# UNITED STATES PATENT AND TRADEMARK OFFICE

APPLICATION NO.	FILING DATE	FIRST NAMED INVENTOR	ATTORNEY DOCKET NO.	CONFIRMATION NO.
10/597,472	08/05/2008	Fumito Hirano	90606.613/ym	1659
54071	7590	02/16/2011		
YAMAHA C/O KEATING & BENNETT, LLP 1800 Alexander Bell Drive SUITE 200 Reston, VA 20191			EXAMINER SCHARICH, MARC A	
			ART UNIT 3611	PAPER NUMBER
			NOTIFICATION DATE 02/16/2011	DELIVERY MODE ELECTRONIC

<b>Office Action Summary</b>	<b>Application No.</b> 10/597,472	<b>Applicant(s)</b> HIRANO ET AL.	
	<b>Examiner</b> MARC A. SCHARICH	<b>Art Unit</b> 3611

## DETAILED ACTION

Fig. 1

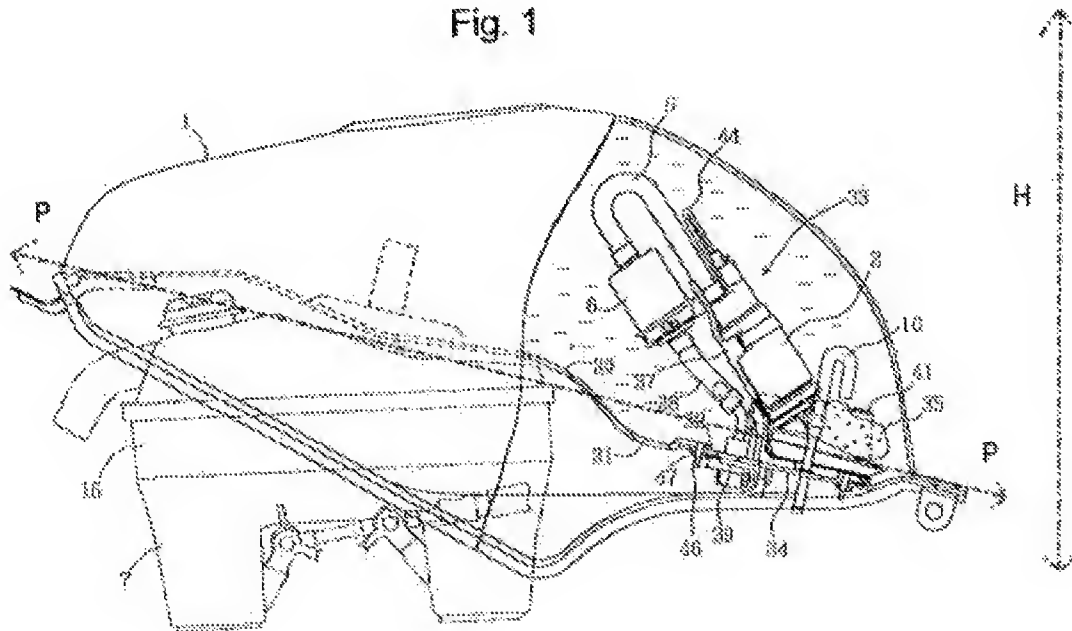
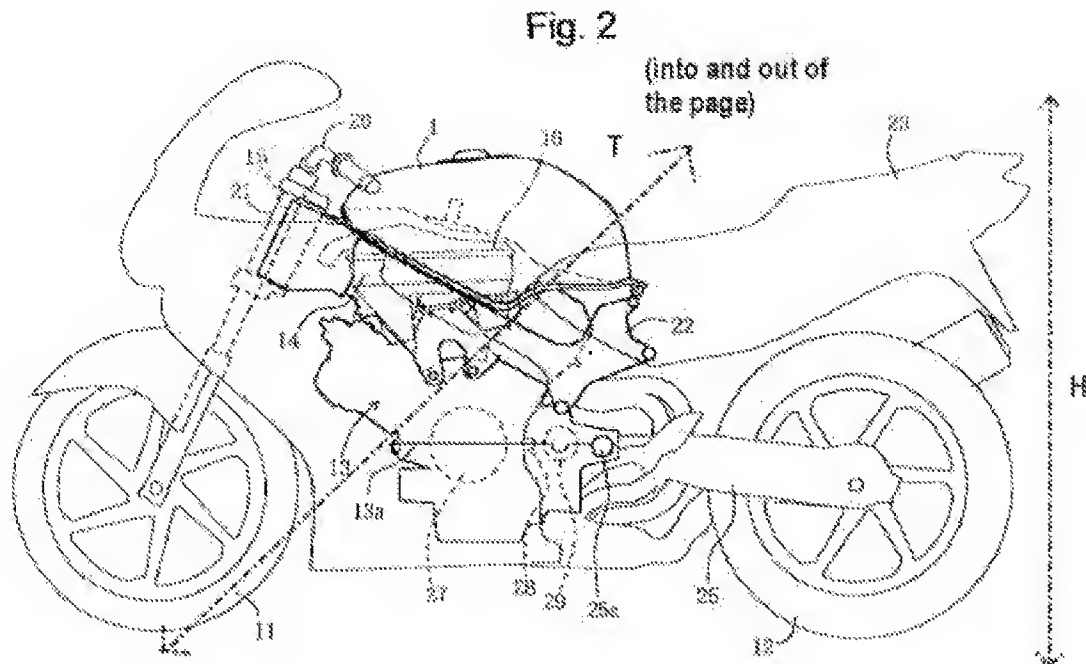
**Claims 11-16, 18, 19 and 21-25** are rejected under 35 U.S.C. 102(b) as being anticipated by Nakashima et al., U.S. Patent No. 6,182,640.

Nakashima et al. discloses a straddle type vehicle [*motorcycle*] (Fig. 2) comprising *at least* a frame assembly [*main frame*] (14), a fuel tank (1) straddling

[*extending overtop and covering*] the frame assembly (14) in a transverse [*side-to-side*] direction (T) [*extending into and out of the page*] relative to a vertical height direction (H) of the vehicle [*see included Figs. 1 and 2 below*], a fuel pump assembly (33) extending into/inside the fuel tank (1) (Fig. 1), the fuel tank (1) comprising a generally horizontal [*flat*] rear surface portion [*part*] (31) formed on a bottom (30) of the fuel tank (1) (Fig. 1) {also see Col. 3, Lines 29-33}, and the fuel pump assembly (33) being mounted to the generally horizontal rear surface portion (31) with a “pump axis” (P) [*see included Figs. 1 and 2 below*] of a strainer (4) (Fig. 3) of the fuel pump assembly (33) extending “generally horizontally”; wherein the frame assembly (14) comprises a frame component [*main frame structure*] that extends at an angle downward and rearward (Fig. 2) such that a rear portion of the frame component [*main frame structure*] is lower than a forward portion of the frame component [*main frame structure*] (see Fig. 2), and the fuel pump assembly (33) is positioned in a rearward portion of the fuel tank (1) (Fig. 1); wherein the fuel pump assembly (33) is positioned in the fuel tank (1) with the “generally horizontally” extending pump axis (P) [*see included Figs. 1 and 2 below*] of the fuel pump assembly (33) also extending “generally transverse” relative to the height direction (H) of the vehicle; and wherein the fuel tank (1) comprises a pump attaching opening (32) defined in at least the generally horizontal rear surface portion (31) and a size of the pump attaching opening (32) is minimized while permitting insertion of the fuel pump assembly (33) into the fuel tank (1) (Fig. 1); wherein the pump attaching opening (32) comprises an elongated configuration [*the opening (32) is covered by a corresponding generally elongated/circular-shaped base plate (34), which is discussed*

*below*]; wherein the fuel pump assembly (33) comprises a generally elongated/circular-shaped attaching portion [*base plate*] (34) (Fig. 5) and the attaching portion (34) is sized slightly larger than the pump attaching opening (32) such that the attaching portion (34) can close and seal off the pump attaching opening (32) (Fig. 1); and wherein the fuel pump assembly (33) further comprises a fuel pump (2) and the attaching portion [*base plate*] (34) is positioned under [*projected underneath*] only a portion [*approx 7/8*] of the fuel pump (2) (Fig. 3).

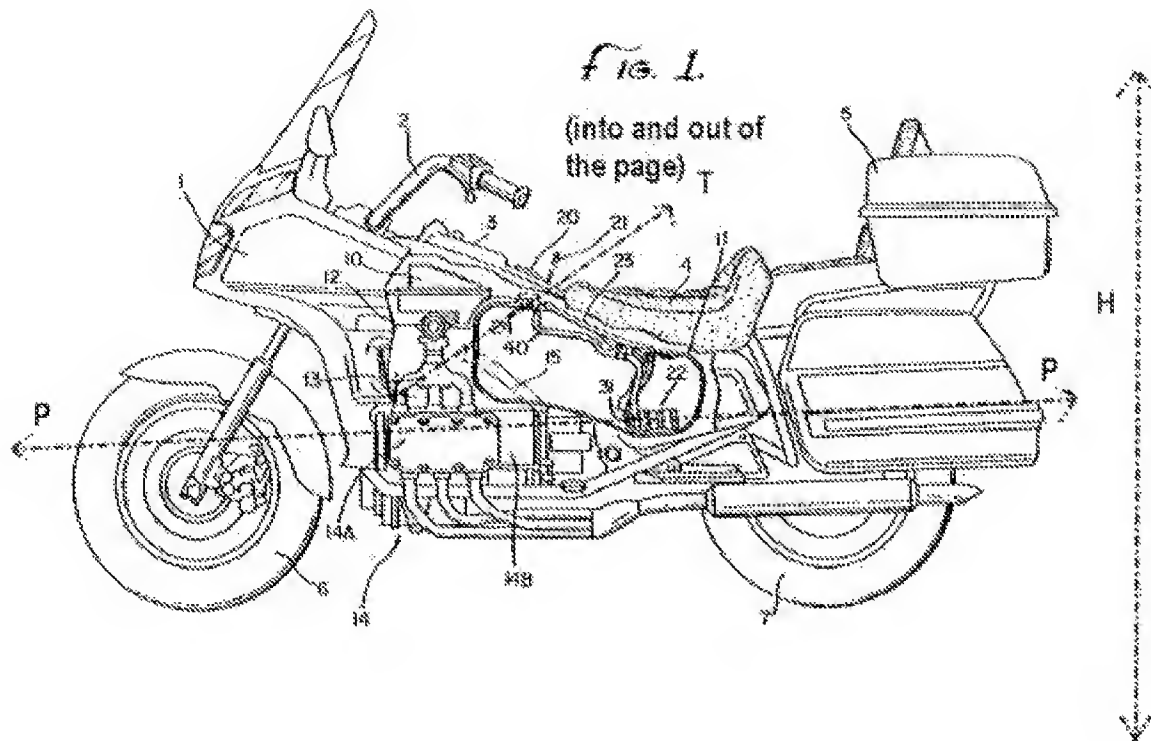
**Claims 11-14 and 18-21** are rejected under 35 U.S.C. 102(b) as being anticipated by Saito et al., U.S. Patent No. 4,871,041.

Saito et al. discloses a straddle type vehicle [*motorcycle*] (Fig. 1) comprising at least a frame assembly [*overall vehicle body*] (unnumbered) which further comprises at least a frame component [*frame element*] (15) [*further described below*], a fuel tank (11) straddling the frame assembly in a transverse [*side-to-side*] direction (T) [*extending into and out of the page*] relative to a vertical height direction (H) of the straddle type vehicle [*see included Fig. 1 below*], a fuel pump assembly [*pump unit*] (22) extending within the fuel tank (11) (Figs. 1 and 2), the fuel tank (11) comprising a generally horizontal [*flat*] rear surface portion formed on a bottom of the fuel tank (11) (Fig. 2), and the fuel pump assembly (22) being mounted to the generally horizontal rear surface portion [*at (31b)*]

(Fig. 2) and having a central “pump axis” (P) [*see included Fig. 1 below*] of the fuel pump assembly (22) extending “generally horizontally”; wherein the fuel tank (11) further comprises an opening [*supply port*] (16) which appears to be capable of receiving the fuel pump assembly (22) therethrough due to the fuel pump assembly (22) being cylindrically shaped and apparently small enough to enter inside of the fuel tank (11) (Fig. 4); wherein the opening (16) of the fuel tank (11) further comprises an “elongated configuration” [*mating cap (17) for covering the supply port (16) contains an elongated handle*] (Fig. 3); wherein the frame component (15) of the frame assembly extends at an angle downward and rearward (Fig. 1) such that a rear portion of the frame component (15) is lower than a forward portion of the frame component (15) (Fig. 1), and the fuel pump assembly (22) is positioned in a rearward portion of the fuel tank (11) (Fig. 2); wherein the fuel tank (11) comprises a recessed forward portion [*bifurcated shape*], the frame component (15) of the frame assembly extending centrally alongside [*within*] the recessed forward portion such that the fuel tank (11) straddles the frame component (15) (Fig. 1) {also see Col. 3, Lines 11-14}, and the fuel pump assembly (22) is positioned rearward of the recessed forward portion of the fuel tank (11) [*the pump unit (22) is positioned well behind where frame element (15) is straddled by the fuel tank (11)*] (Fig. 1); and wherein the fuel pump assembly (22) is positioned in the fuel tank (11) with the “generally horizontally” extending pump axis (P) [*see included Fig. 1*] of the fuel pump assembly (22) also extending “generally transverse” relative to the height direction (H) of the straddle type vehicle.
